ADDENDUM NO. 1

PROJECT: AUTOMOTIVE TECHNOLOGY CENTER RELOCATION AND RENOVATION
8204 HWY 311, SELLERSBURG
IN, 47172

ARCHITECT'S PROJECT NO.: 26-064

SHEET TITLE
FIRST FLOOR
SHEET METAL PLAN

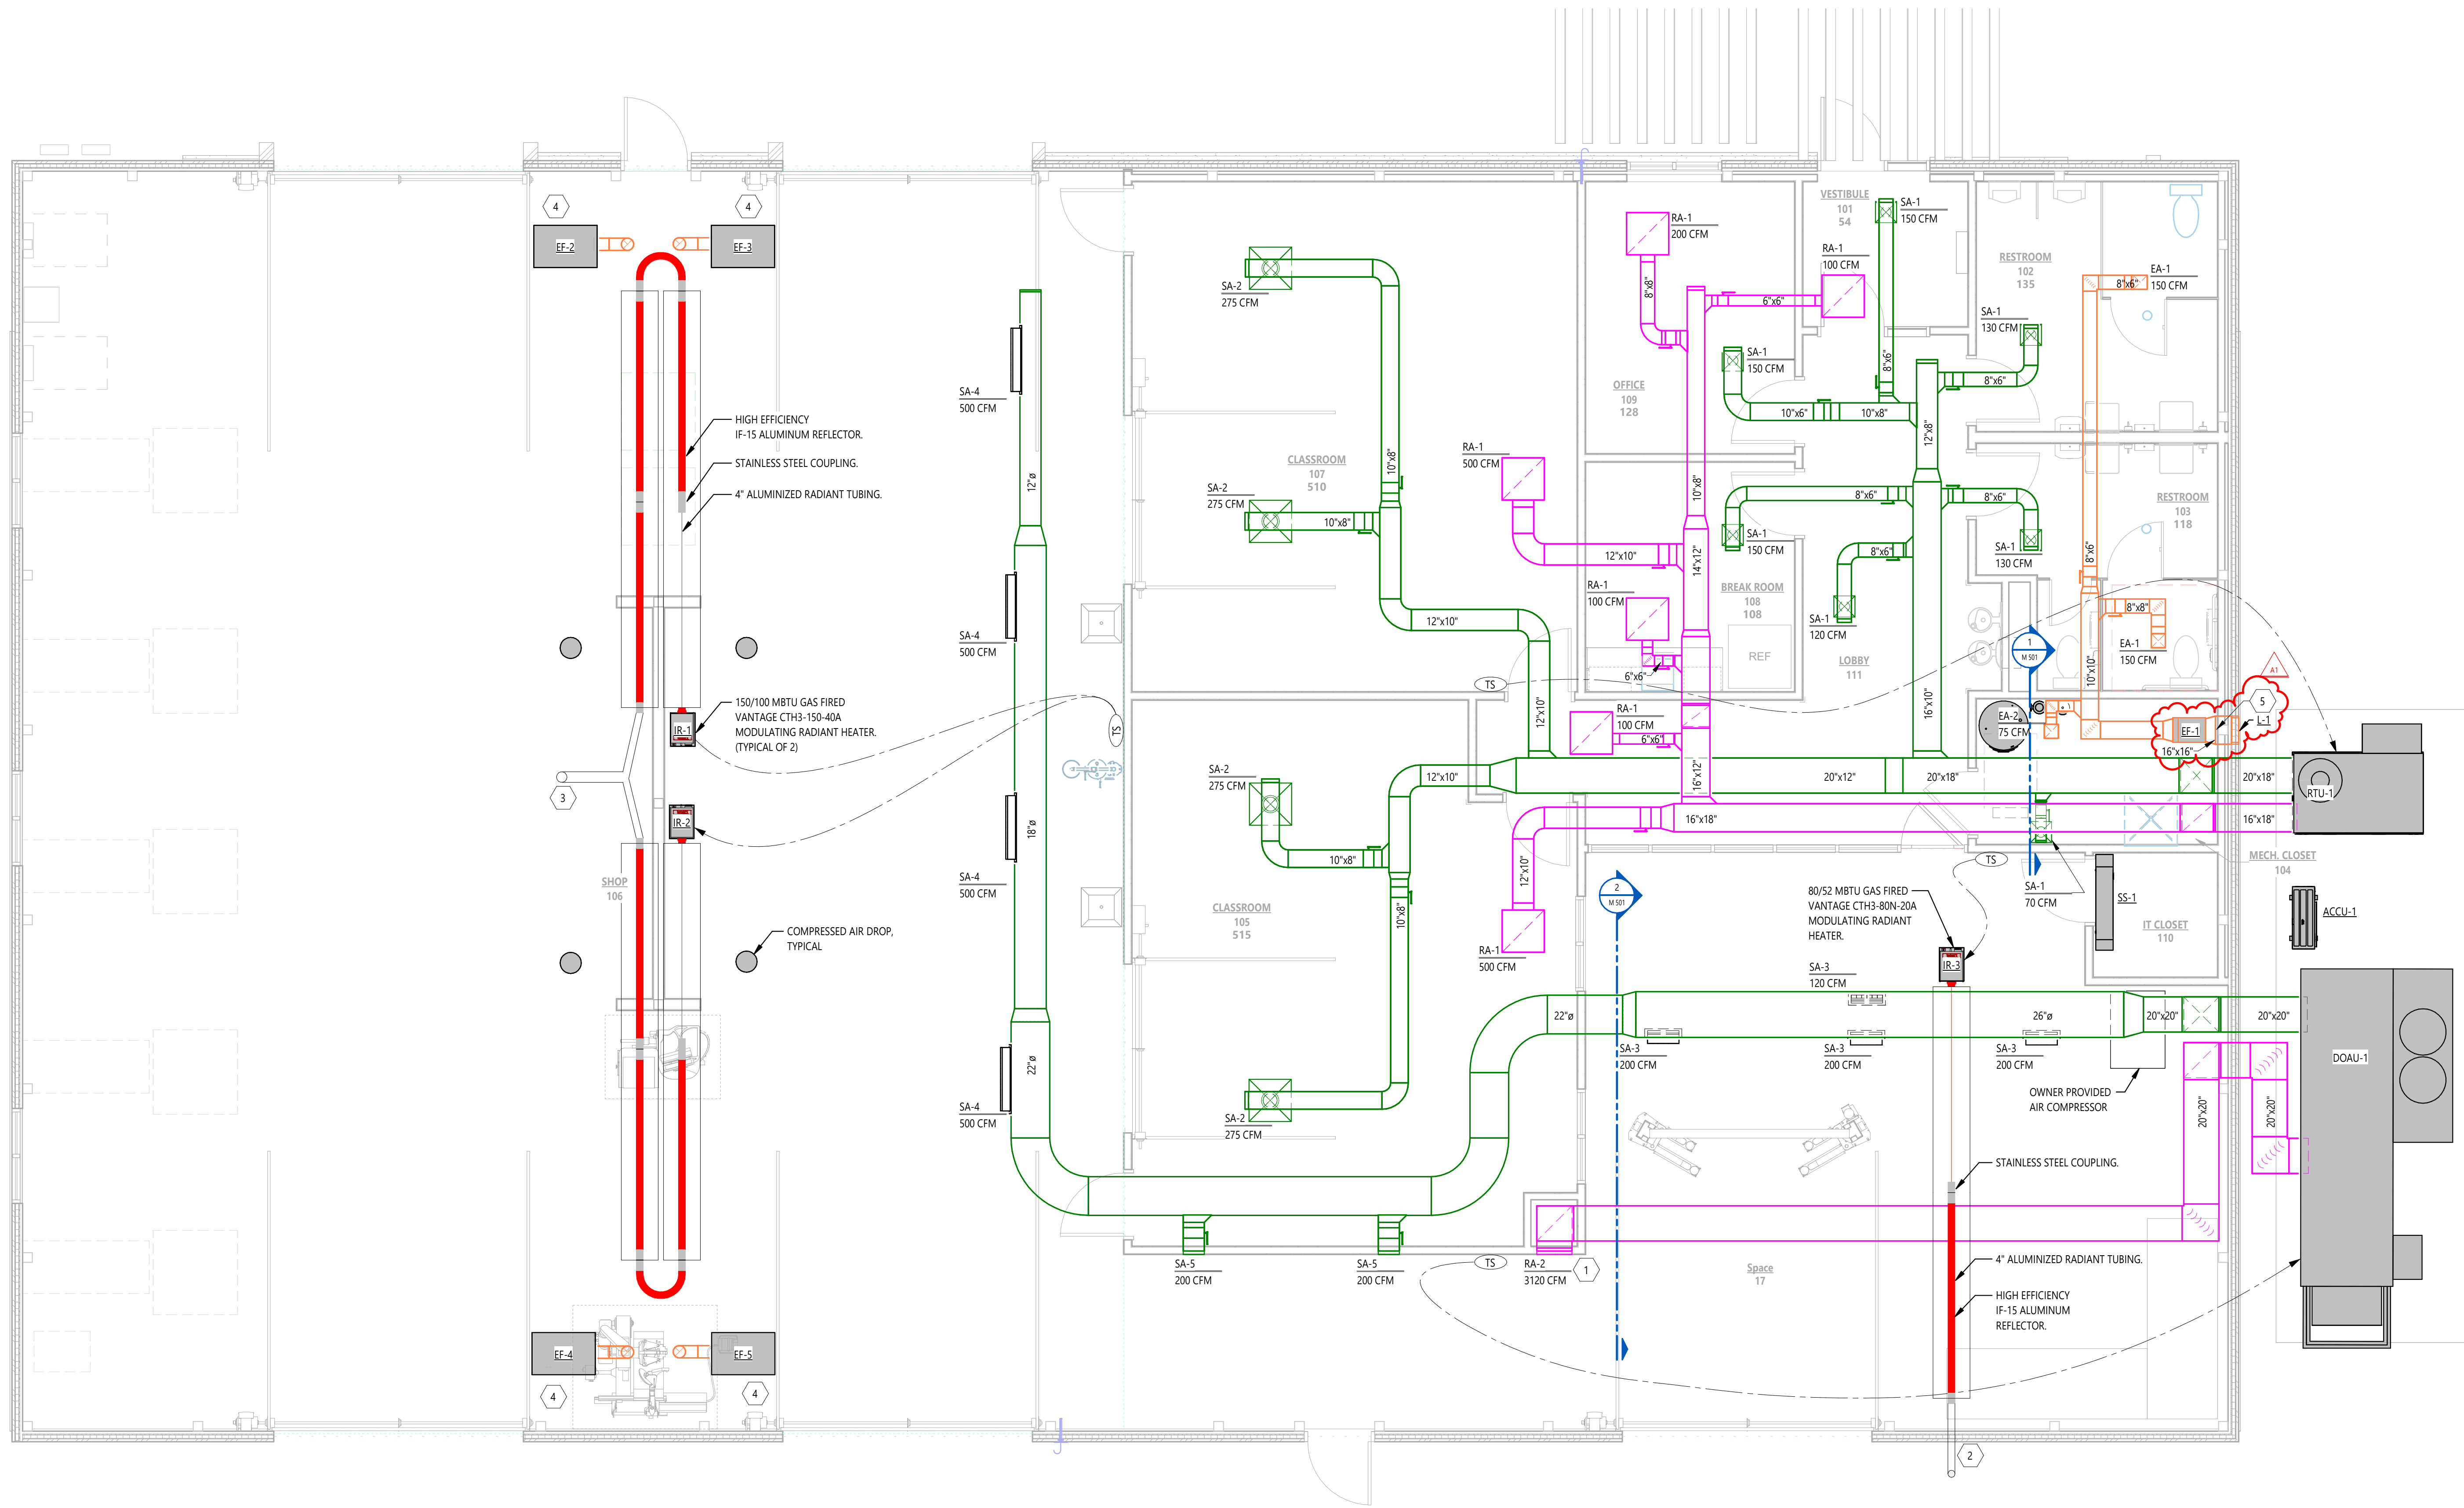
ADD-1 Item No. D-1 - M 101

Added a motorized control damper to the exhaust fan which is to be controlled locally from the exhaust fan as described in drawings.
